KEYSTONE XL PIPELINE PROJECT

0384-SD-P4-425.5-425.8-S

KEYSTONE XL PIPELINE PROJECT PIPELINE ROUTE VARIATION FORM			
1	<b>VARIATION TYPE:</b>	Refinement: <input type="text"/>	Reroute: <input checked="" type="checkbox"/>
		Footprint: <input type="text"/>	Design: <input type="text"/>
		Centerline: <input checked="" type="checkbox"/>	Pump Station: <input type="text"/>
		Valve Site: <input type="text"/>	CAR: <input type="text"/>
2	<b>LOCATION:</b>	Sketch: <input type="text" value="Attached"/>	Pictures: <input type="text" value="N/A"/>
	State: <input type="text" value="SD"/>	County: <input type="text" value="Haakon"/>	Quad Map: <input type="text" value="N/A"/>
	Township: <input type="text" value="07N"/>	Range: <input type="text" value="17E"/>	Aerial Map: <input type="text" value="See attached map sheet"/>
	Section: <input type="text" value="28"/>	Centerline: <input type="text" value="8/15/2012"/>	MP: <input type="text" value="425.49"/> to <input type="text" value="425.82"/>

*Proposed Route Variation 0384-01*

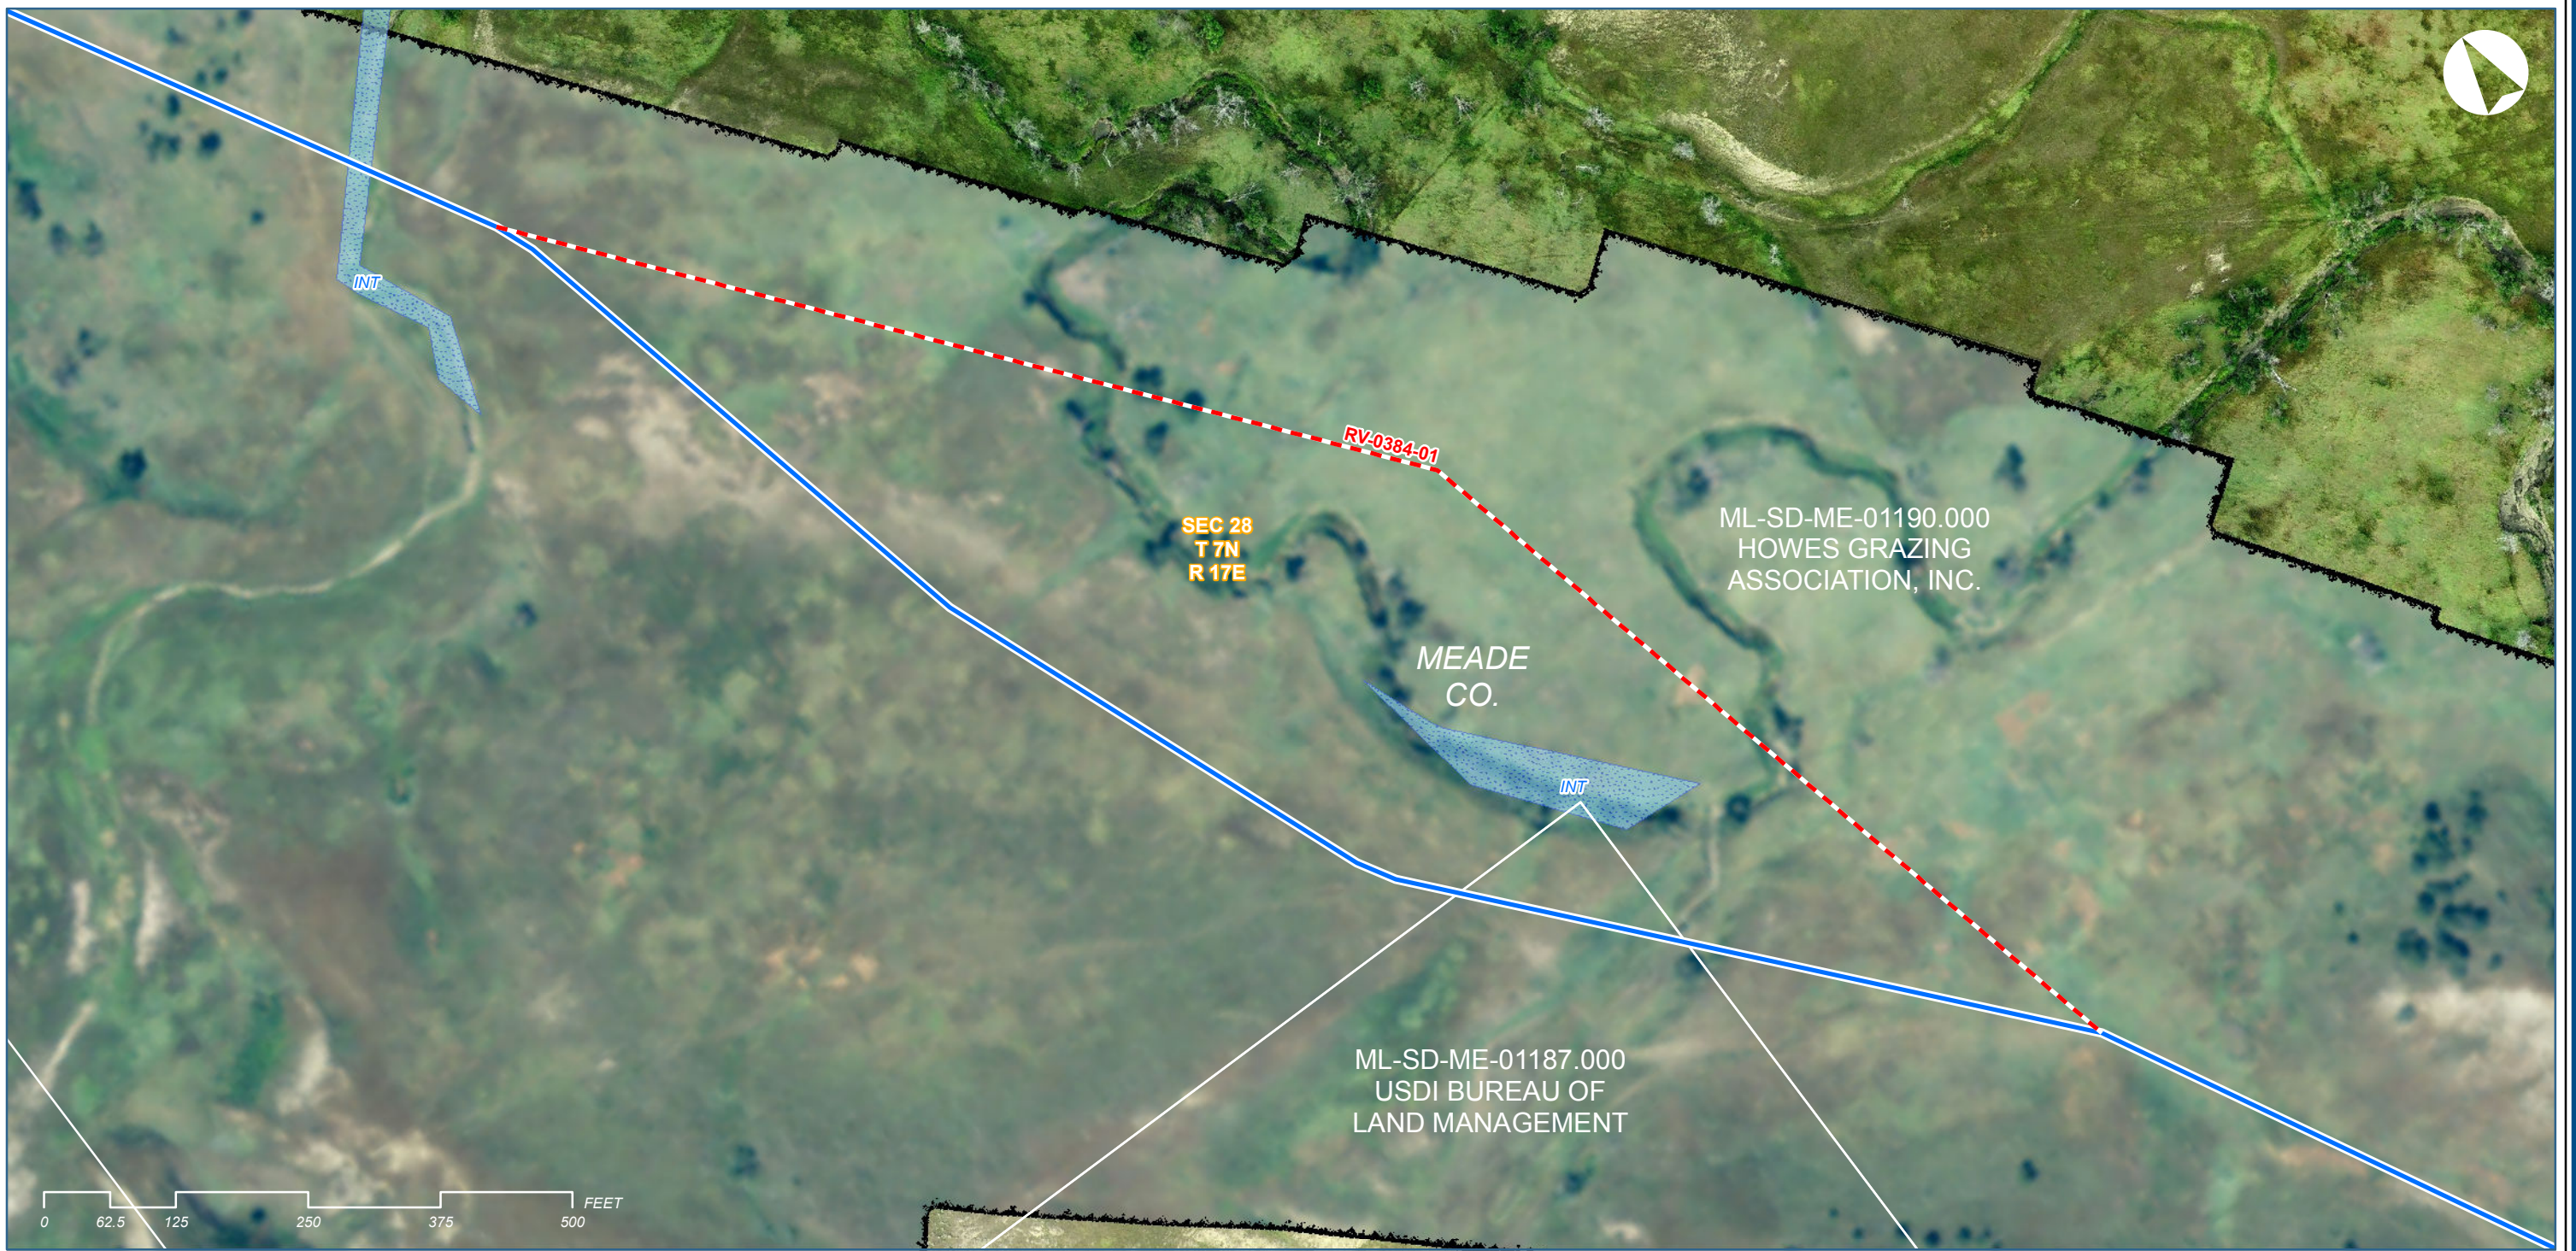
3	<b>REASON FOR ROUTE VARIATION</b> (Please include reason for route variation):		
	<p>The primary reason for this route variation is to avoid impact to BLM tract (SD-ME-01187) and still avoid an HDD drill at the crossing of Narcelle Creek (Feature ID: exp-WB-13014, near MP 425.6). The Landowner (Howes Grazing) has requested the banks of the creek remain laid back for a cattle crossing after construction.</p> <p>Route variation RV-0252-01 (implemented to 08/15/2012 CL) shifted the CL/Workspaces west to avoid ridgelines, rough terrain and dropoffs and to avoid the need for an additional HDD in this area. However, due to lack of accurate information at the time, it was not known with certainty the owner of tract SD-ME-01187 (now USDI Bureau of Land Management). This proposed route variation will shift the CL east to avoid impacting this tract. This reroute is requested by Engineering based on input from the field.</p>

<b>DETAIL ROUTE VARIATION</b> (Please describe route variation in detail):		
	<p>The proposed route variation starts near MP 425.5 and deviates ~19.5° east of current centerline. It extends in this direction for ~918 ft. before making a turn south. It then continues for ~822 ft. and rejoins the current CL near MP 425.8.</p>		
	<b>ADDITIONAL IMPACTS</b> (Please include any additional impacts which may affect cost; crossings, induction bends, etc.):		
	<p>2 Tracts are impacted by this Centerline reroute:                      ML-SD-ME-01187.000 (USDI Bureau of Land Management) (To be Offline)                      ML-SD-ME-01190.000 (Howes Grazing Association, Inc.)</p> <p>The proposed route variation falls outside of current environmental surveyed corridor, so additional costs associated with environmental surveys will be incurred.</p> <p>Costs savings include the elimination of a potential HDD drill (\$955,000) and the elimination of additional surveys (environmental and civil) for the potential pullback (~\$3,700). The use of the conventional open cut method (~1300/ft for a 4 ft. depth crossing) at the 2 crossings of Narcelle Creek yield construction costs: 1st crossing ~57 length [measured surveyed top of bank+15 ft. from each bank] ~\$74,100, and for the 2nd crossing ~ 98 length [measured surveyed top of bank+15 ft. from each bank] ~\$127,400. Rock &amp; Sheet piling costs were not included in the estimate. For a net estimated savings of ~757,200</p>
